**ADDENDUM 01**

Addendum #	01	Date Issued	03/21/2025
Project Name Job #	SWN 0509, Waneta Hall Renovate Restrooms	OSE #	R0325--15X
		EAPC #	20256780
Bid Date Time	April 3, 2025		3:30pm

PROJECT DESCRIPTION
SWN 0509, WANETA HALL RENOVATE RESTROOMS (OSE# R0325--15X)

DRAWING TITLE
FIRST FLOOR HYDRONICS PLANS

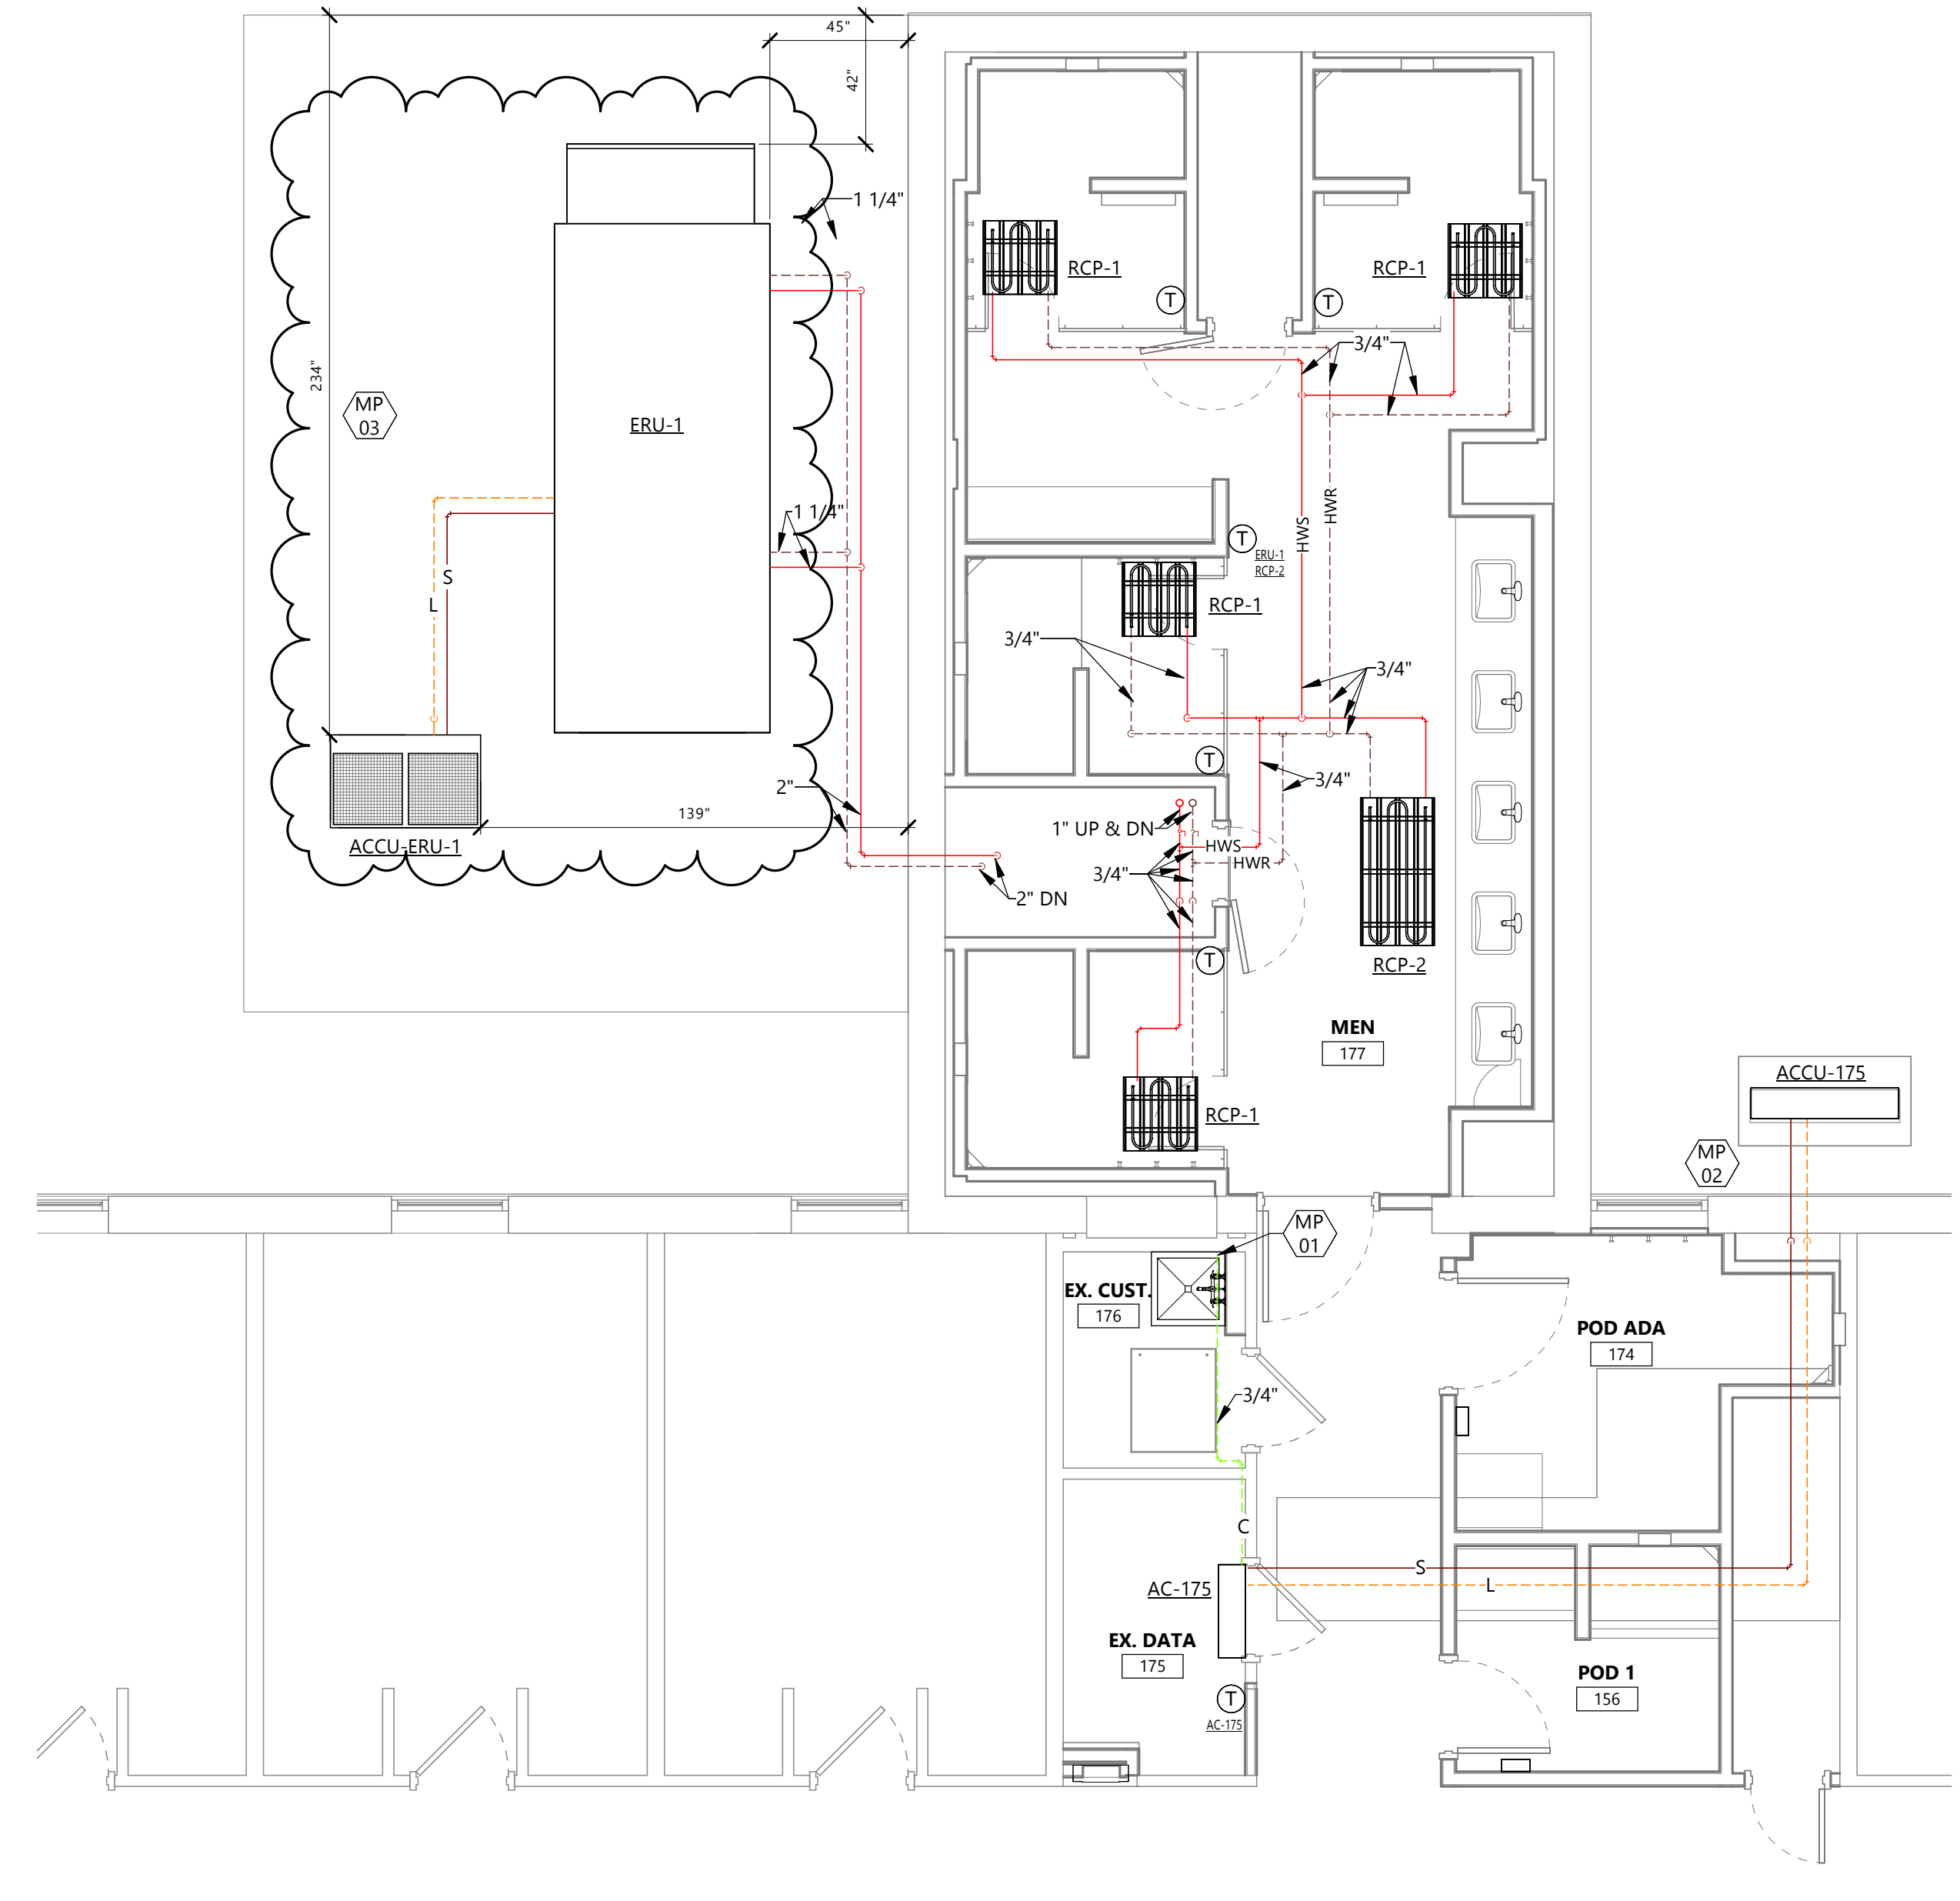
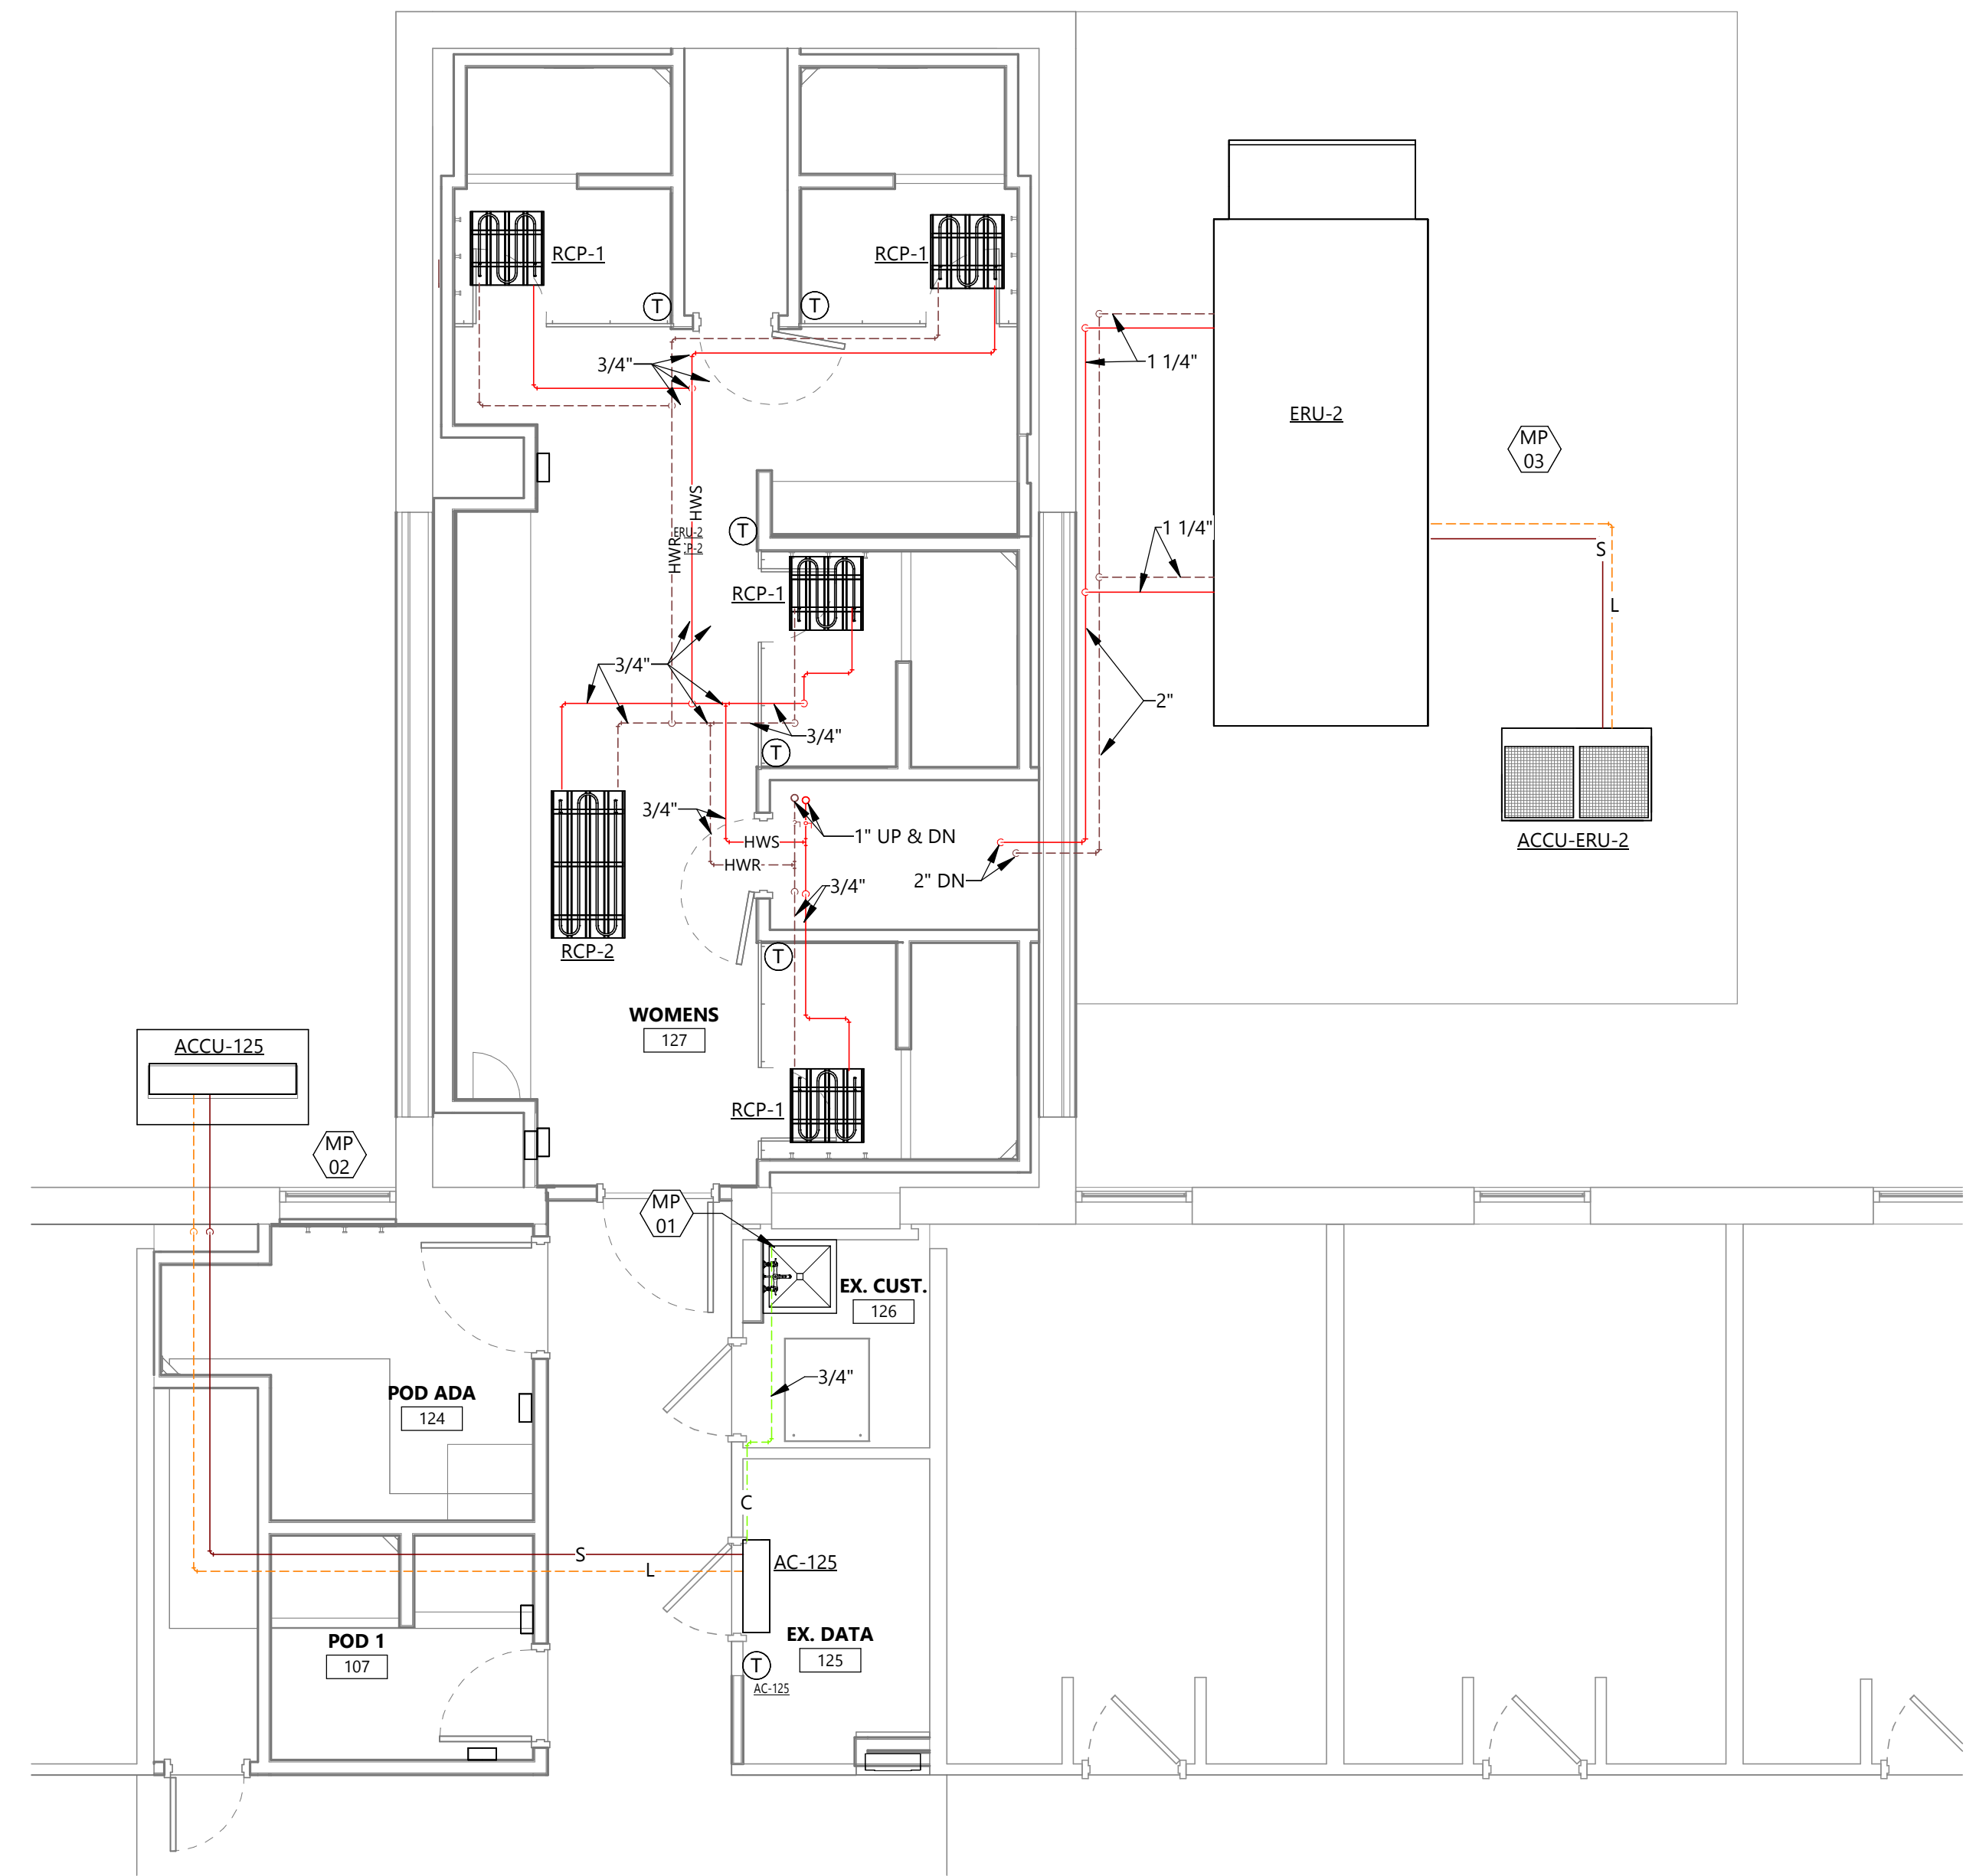
P200	REVISE plumbing pipe routing to stay within tunnel space regarding Alternate 02 work.
P201	REVISE plumbing pipe routing in wall associated with Alternate 02.
M201	REVISE ERU's and associated ACCU's locations for concrete pad and clearances.
M301	REVISE ERU and ACCU locations for concrete pad and clearances. ADD section view for ductwork installation.
E101	CLARIFIATION on existing panel names.
E102	CLARIFIATION on panel names.
E103	CLARIFIATION on panel names and demo at RM 326.
E200	ADD location for MDP.
E201	ADD location for mechanical equipment and duct smoke detectors. Add clarification on alternates. REVISE power at alternates ADD notes 5 and 6.
E202	ADD clarification on alternates. Add notes 3 and 4. REVISE power at Study rooms
E203	ADD note 4 for data rough in. Update power at Study rooms
E301	ADD clarification on lighting types and occupancy sensors.
E302	ADD clarification on lighting types and occupancy sensors.

MP 02 INSTALL ACCU ON CONCRETE PAD. ROUTE & SIZE REFRIGERANT PIPING PER MANUFACTURER'S INSTALLATION REQUIREMENTS. FIELD VERIFY ACCU LOCATION TO MAINTAIN COIL PULLS AND ACCESS TO ERU.

MP 03 CONCRETE PAD FOR ERU & CONDENSING UNIT BY G.C. SLAB WITH #4'S AT 12" ON CENTER EACH WAY. PROVIDE PIPE SUPPORTS SUITABLE FOR GROUND MOUNT APPLICATION ON PAD PER SPECIFICATION.
